THE GLIDING FEDERATION OF AUSTRALIA

AIRWORTHINESS DIRECTIVE GLIDERS/POWERED SAILPLANES.

GFA/AD 218
SZD 21
Issue 1
23/11/1981
Sheet 1 of 2

Reinforcement of the central rib supporting the elevator in
the trailing part of the stabiliser.

BULLETIN No BA-011/81 "JANTAR"

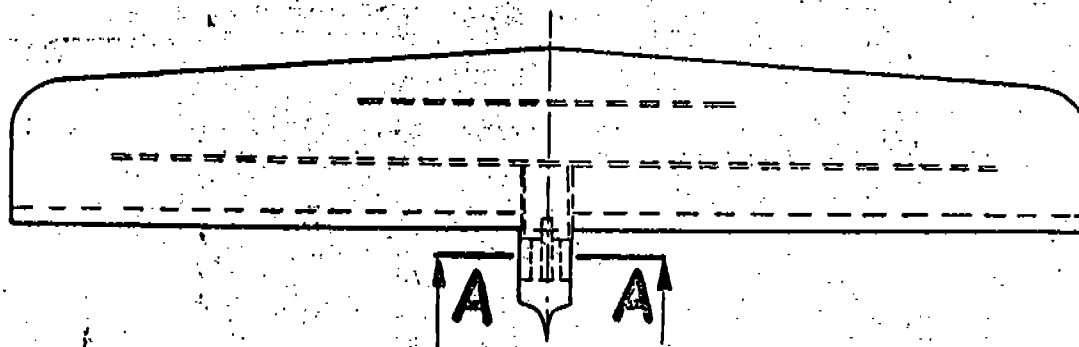
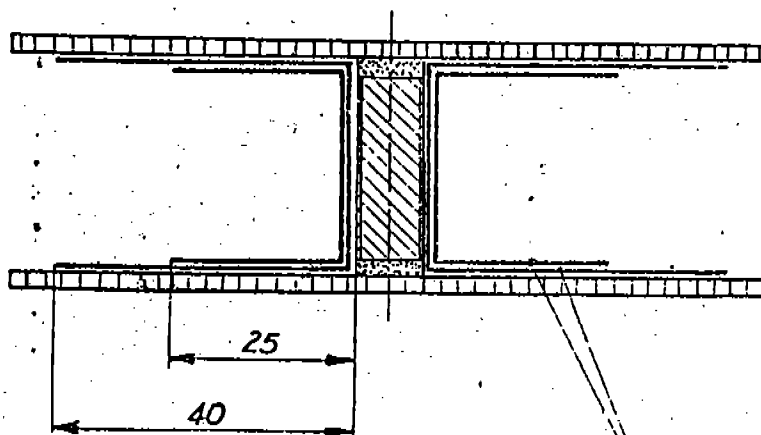
- (a) A thorough inspection is to be made of the centre rib area for
delamination. This must be repaired at the same time as the
structure is reinforced.
- (b) The centre section must be carefully prepared by thorough
degreasing and rubbing back with coarse paper.
- (c) The additional reinforcement sections are to be laid in,
following the instructions on Sheet 2.
- (d) When re-assembling the elevators check clearances carefully
in the centre rib area.
- (e) Carry out an Independent control check.
- (f) Full modification details to be entered into the log book.
- (g) Remove the speed limiting placard and sign off the restriction
of the Maintenance Release.

X Reinforcement to extend along the rib as far as possible.
